**RE: Balloon Fiesta Park – Site Infrastructure Improvements  
9201 Balloon Museum Dr NE  
Grading and Drainage Plan  
Engineer’s Stamp Date: 03/03/2026  
Hydrology File: B17D001  
Case # HYDR-2026-00081**

Based upon the information provided in your submittal received 03/04/2026, the Grading & Drainage Plan is not approved for Rough Grading. The following comments need to be addressed for approval of the above referenced property:

**EXISTING DRAINAGE  
MANAGEMENT PLAN**

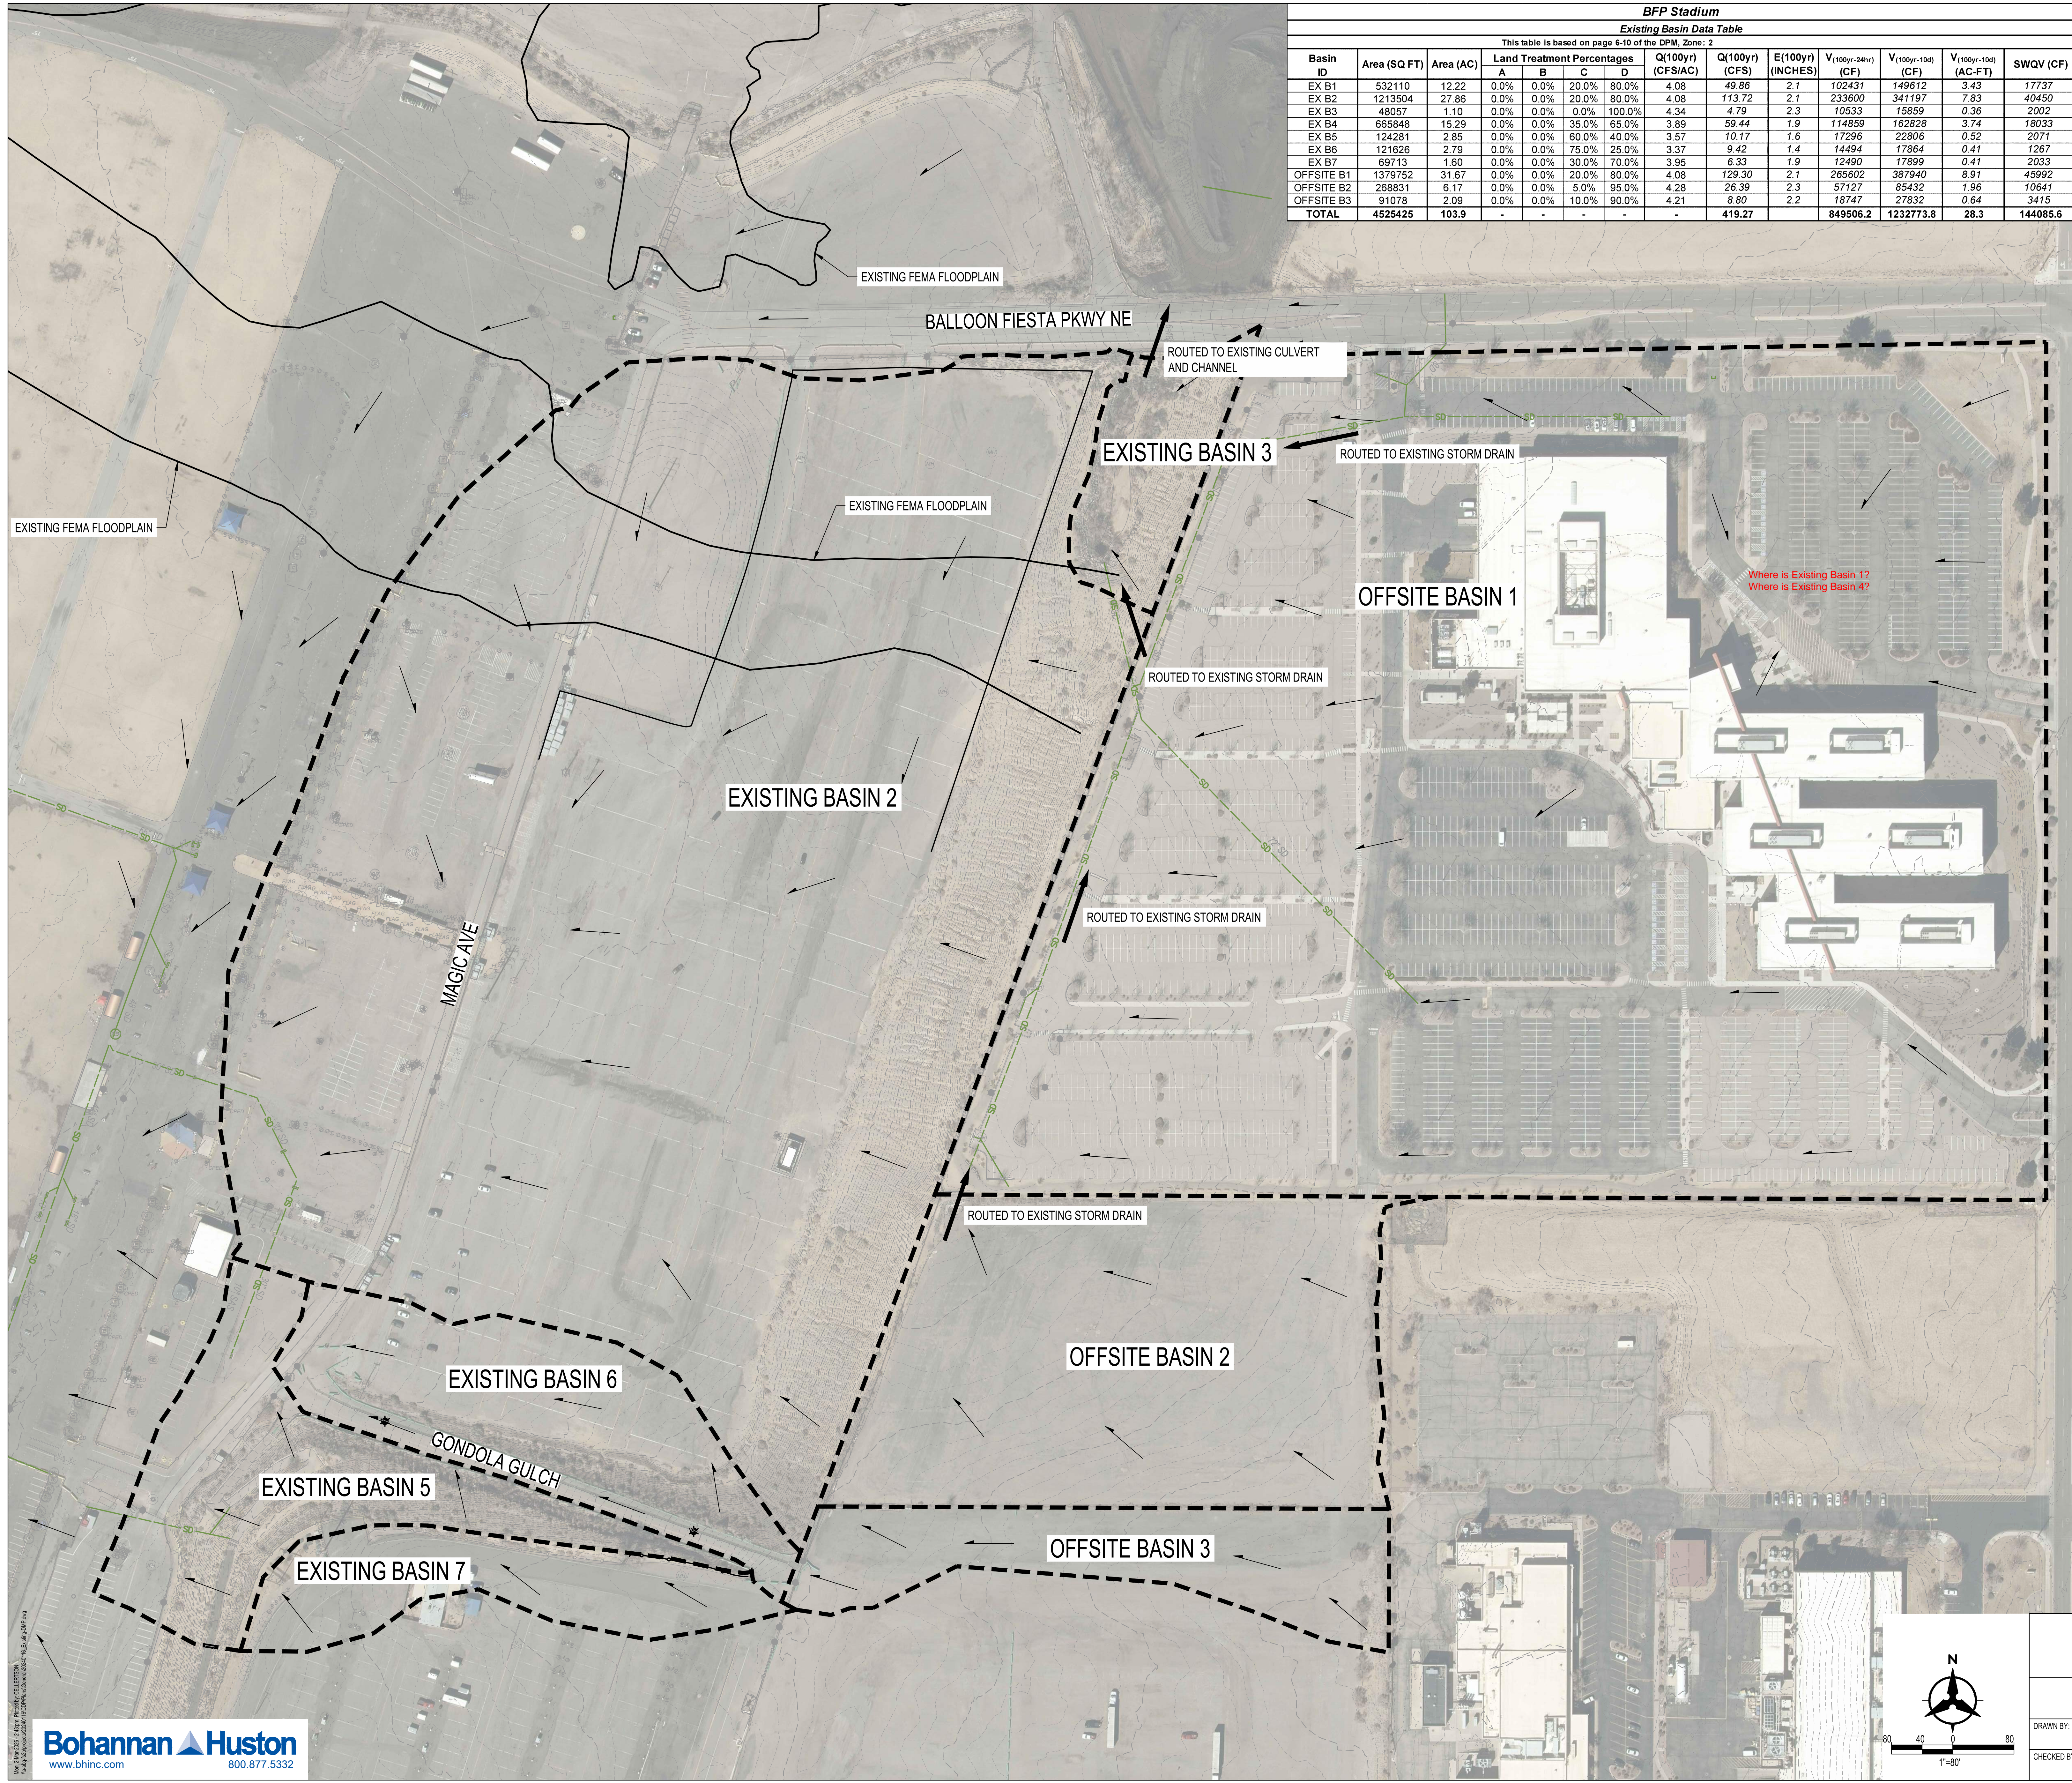
1. P. 1 of 2 – Label Existing Basin 1 and Existing Basin 4 on map.
2. P. 2 of 2 – Show existing FEMA Floodplain on the proposed Drainage Management Plan.
3. P. 1 and 2 – Add a column in the Basin Data Tables that shows the total acreage for Treatment Area ‘D’.

PROPOSED CONDITIONS

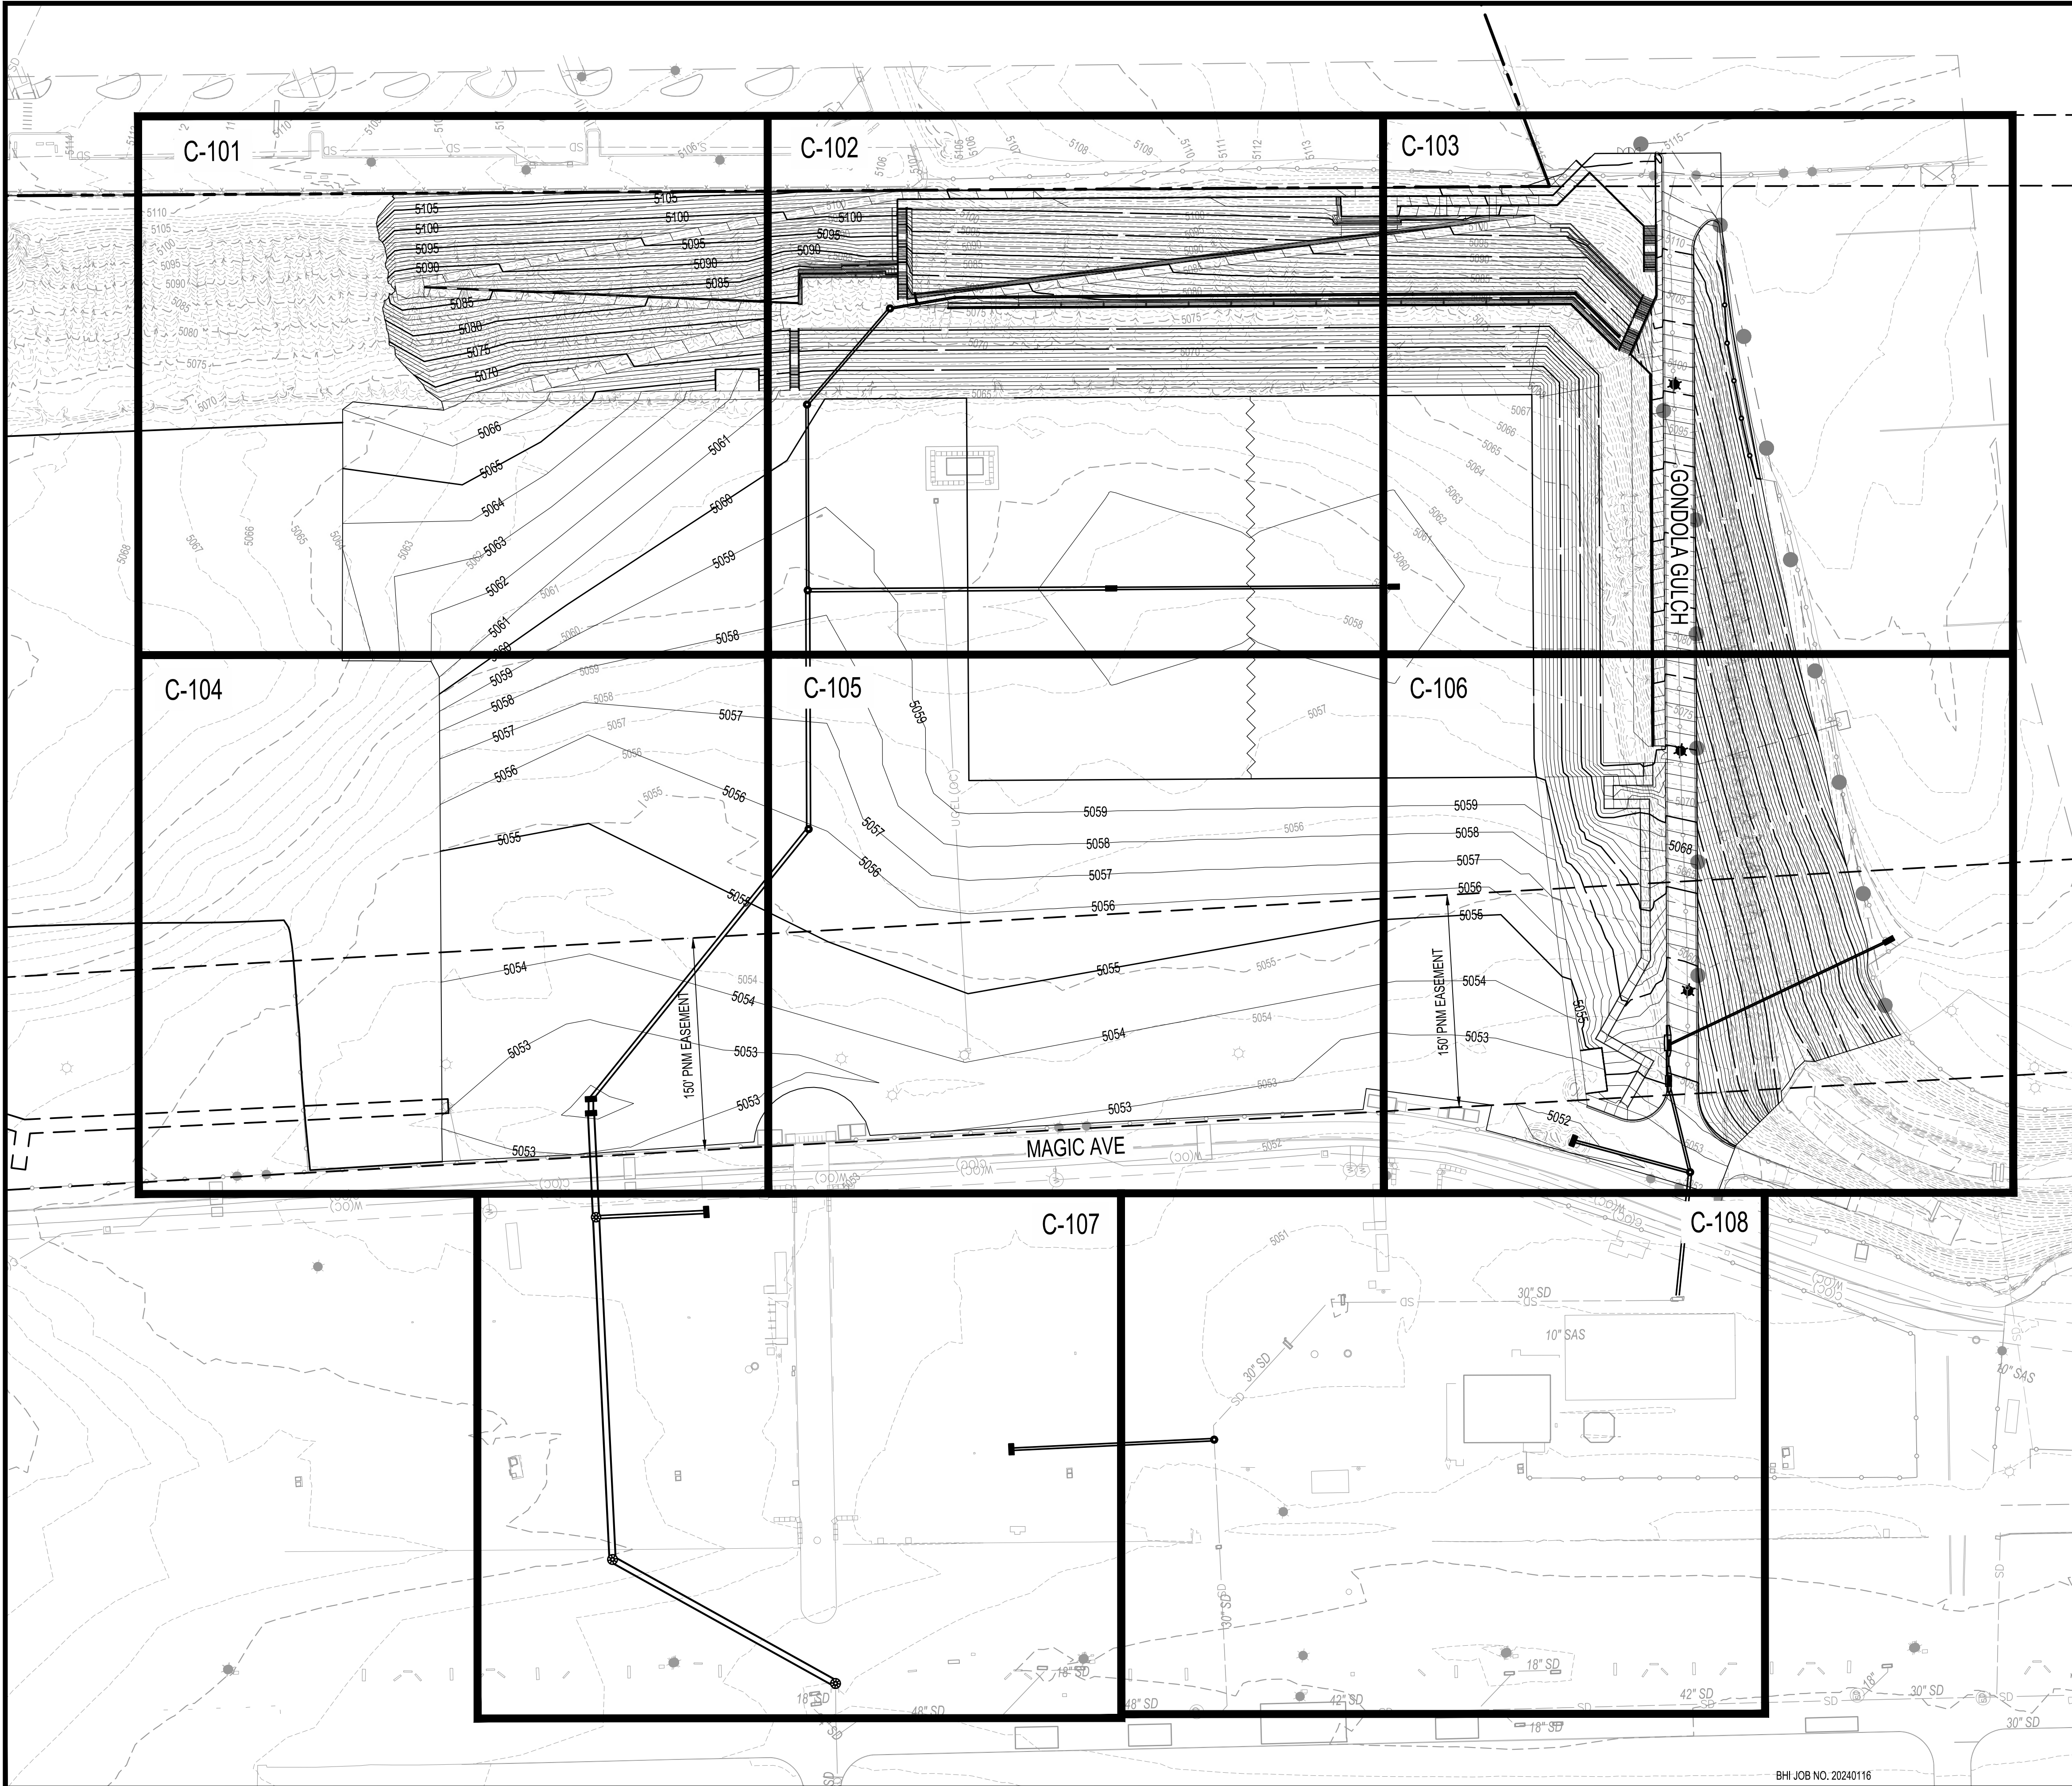
4. P. 8 of 38 – Sheet C-100 – The tag for C-108 is slightly blocking the proposed storm drain, please move this label.

**BFP - SITE INFRASTRUCTURE IMPROVEMENTS  
 GRADING PLAN**

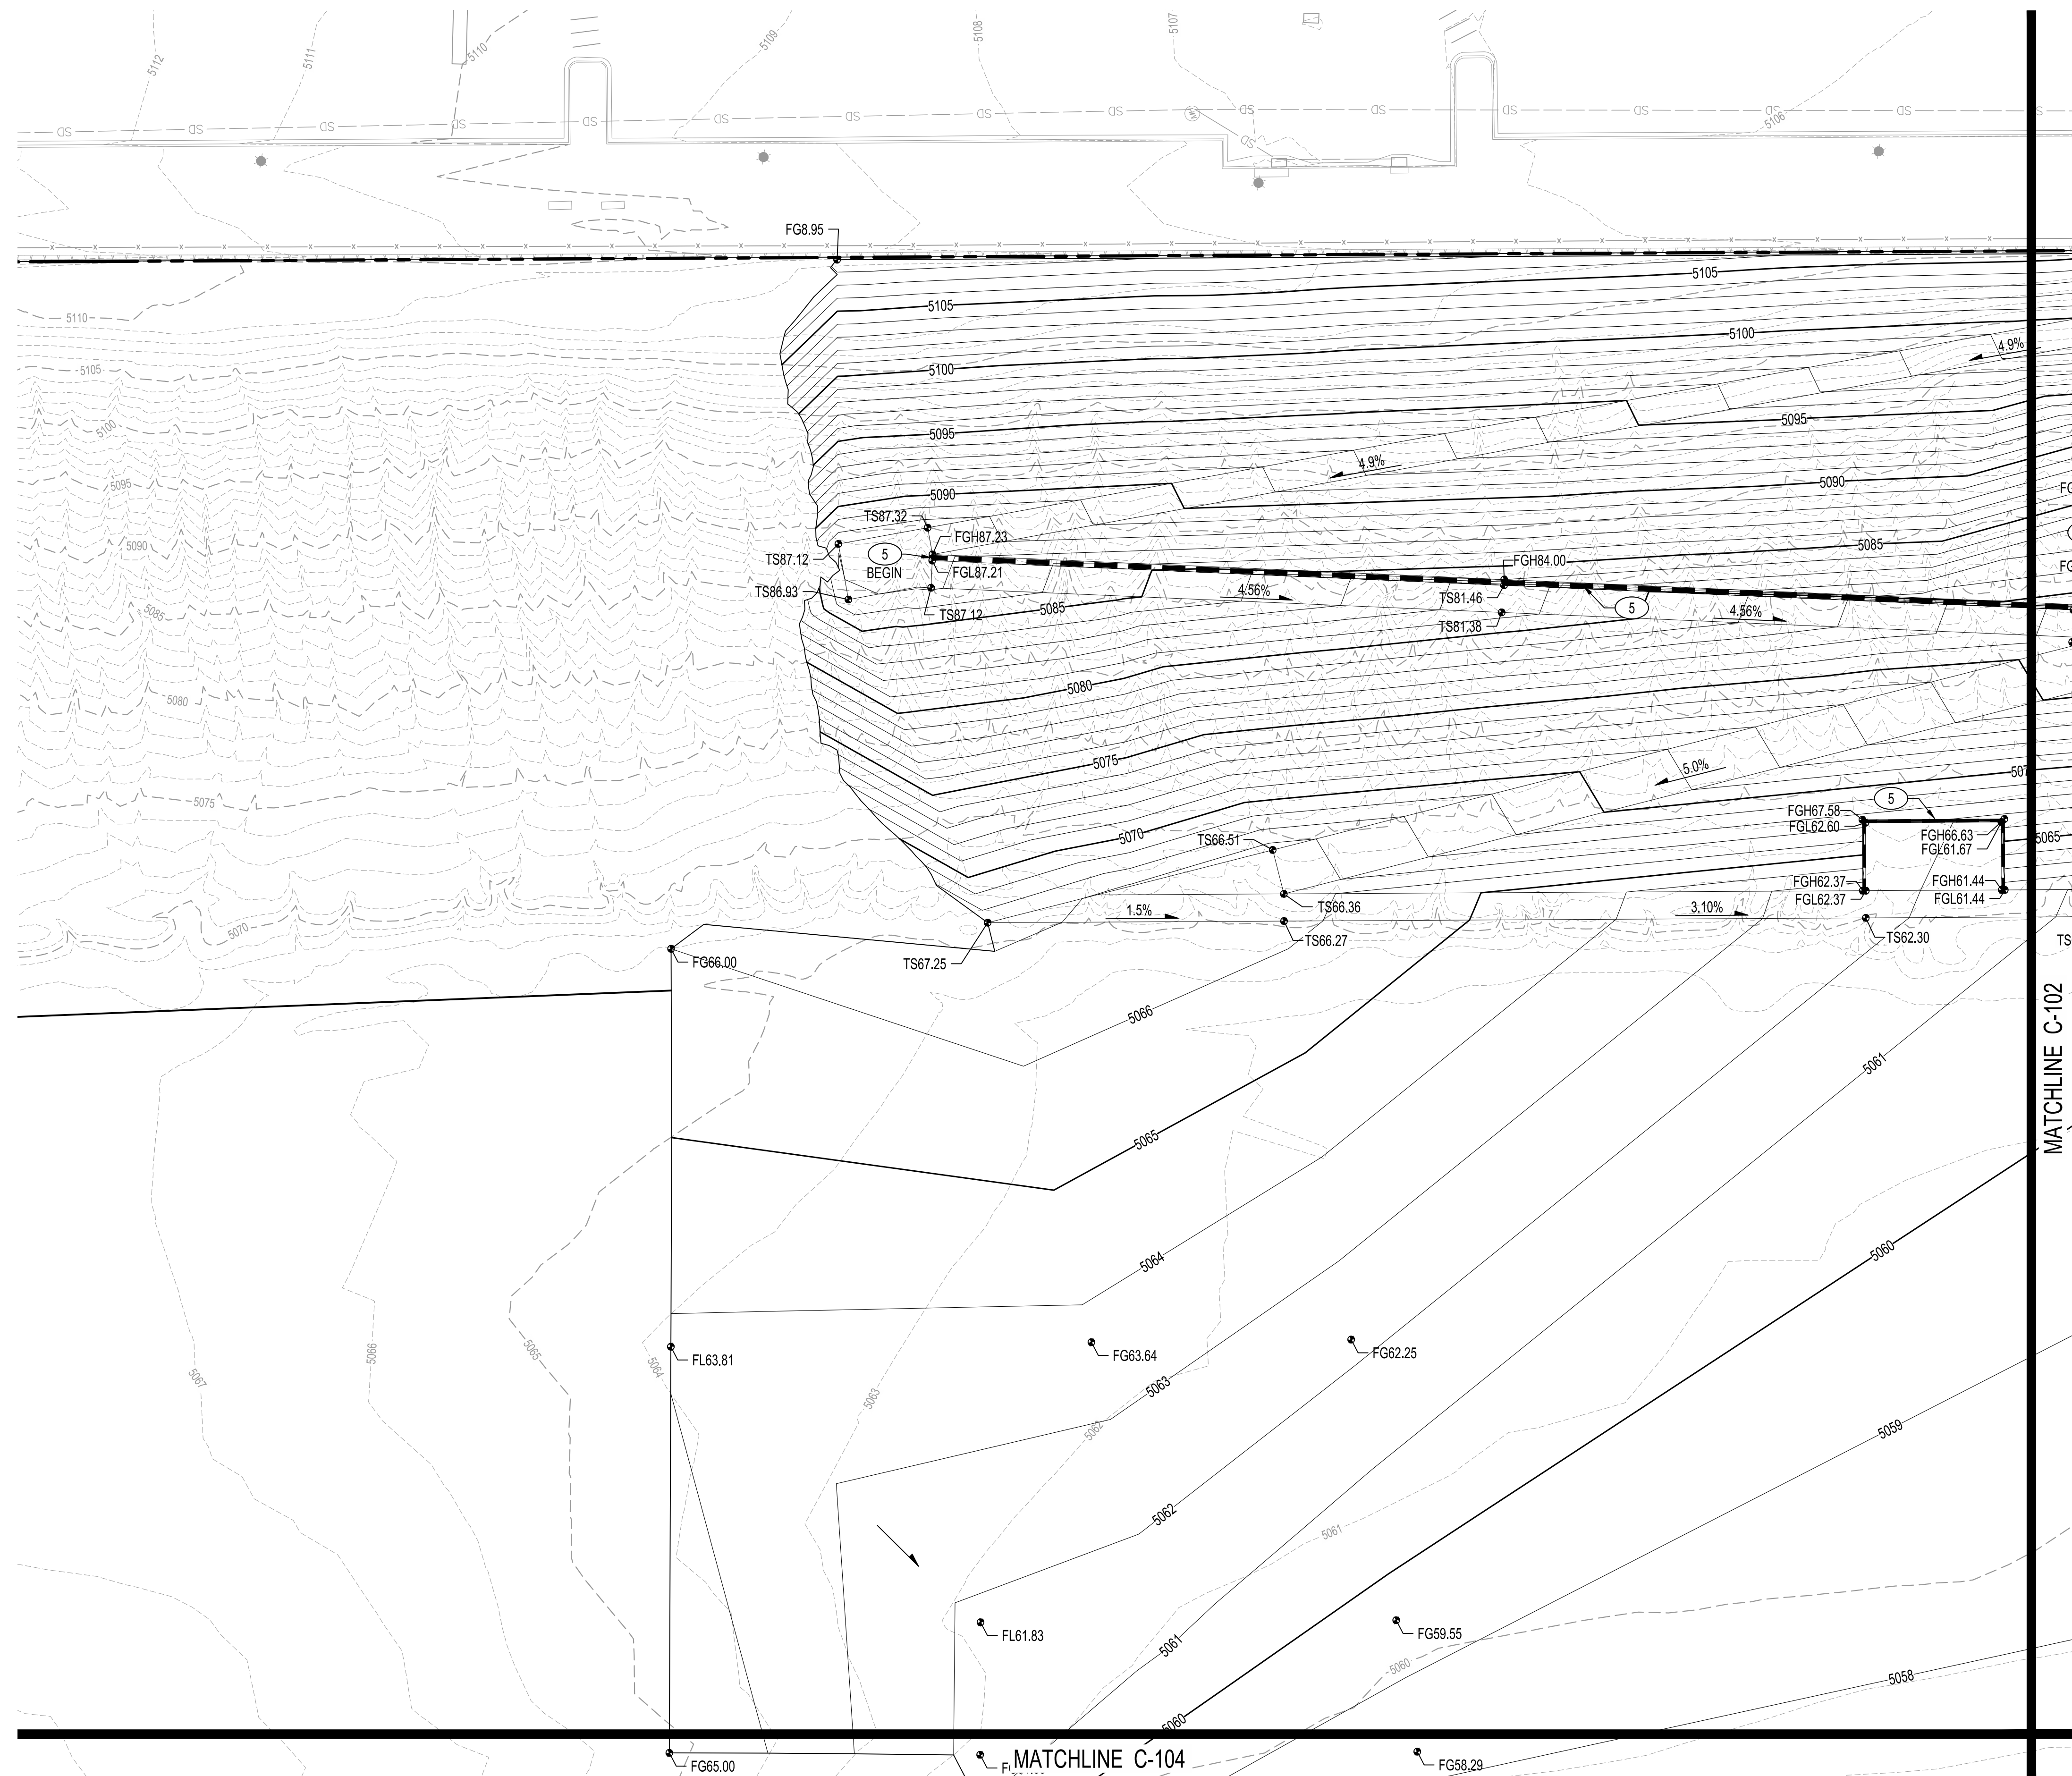
5. P. 9-16 – Sheets C-101 through C-108 – Only call out RCP on grading keyed notes, remove HDPE.

○ GRADING KEYED NOTES	
1.	INSTALL STORM DRAIN PIPE (RCP <del>OR HDPE</del> PER ASTM D2648 OR APPROVED EQUAL). SEE PLAN FOR SIZE & SLOPE.
